SB-GA8-2009-56

Service Bulletin

Overheating of overhead electrical connection used by cabin fresh air blower.

All GA8 aircraft with serial numbers GA8-00-004 to GA8-06-104, GA8-06-106, GA8-06-107, GA8-07-109 and GA8-07-111.

Figure 1

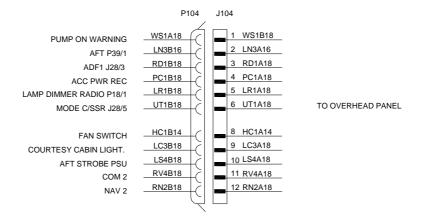
- 1.1. Pull or open all the underfloor circuit breakers.
- 1.2. The affected connectors P104 and J104 are located port side just aft end of the electrical overhead panel. Refer to Figure 1. Remove the forward most centre interior roof panel to access the connectors. Pin 8 of the connectors are used for the blower fan circuits, HC1A14 and HC1B14.

2.1. Replace the electrical plug and cap housing and associated crimp contacts as per original aircraft wiring. Connector P104 requires housing part number 1-480708-0. Connector J104 requires housing part number 1-480709-0. Refer to Figure 1 of this Service Bulletin for the pinout for each connector. The 18 AWG wires require crimp contacts part number 350689-1 & part number 350690-1. Crimp contact part numbers 350547-1 and 350550-1 are used on the 14 and 16 AWG wires. Crimp tool HTR 11-01-0084 (Sargent Tools) is recommended for this task. Use nest A for 18 AWG wire and nest B for the 14 and 16 AWG wires.

Figure 2

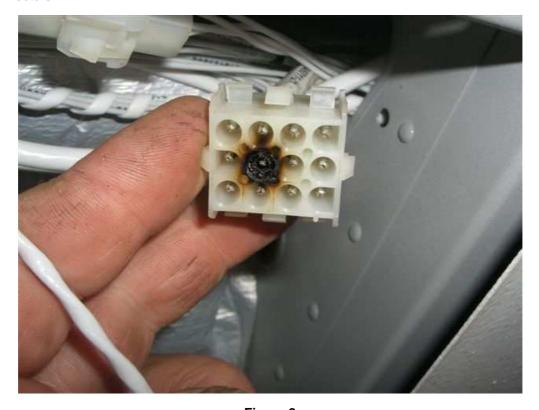
1.3. Inspect the connector for signs of burning or charring. Figures 2 and 3 depict damaged connectors.

1.4. If no evidence of heat damage is evident then re-install the interior panels using the existing fasteners. Proceed to Section 2 if evidence of heat damage exists.

Figure 4

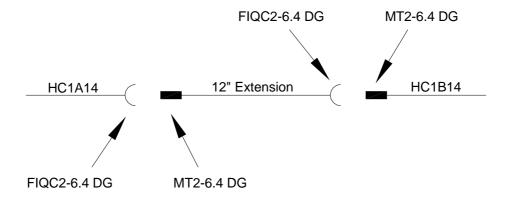
- 2.2. If possible, remove the contact crimp pin and socket attached to circuits HC1A14 and HC1B14 from connectors J104 and P104. Cut off the crimp contacts. If the crimp contacts associated with circuits HC1A14 and HC1B14 cannot be readily removed, cut the wires as close as possible to the rear of each of the connectors.
- 2.3. Cut a length of 14 AWG wire (M22759/16-14-9) to 12". Using male and female lug terminals insert the 12" length of wire in between circuits HC1A14 and HC1B14 as shown in Figure 4. The connections are to be covered in heat shrink tubing. Refer to the Parts table for terminal part numbers.
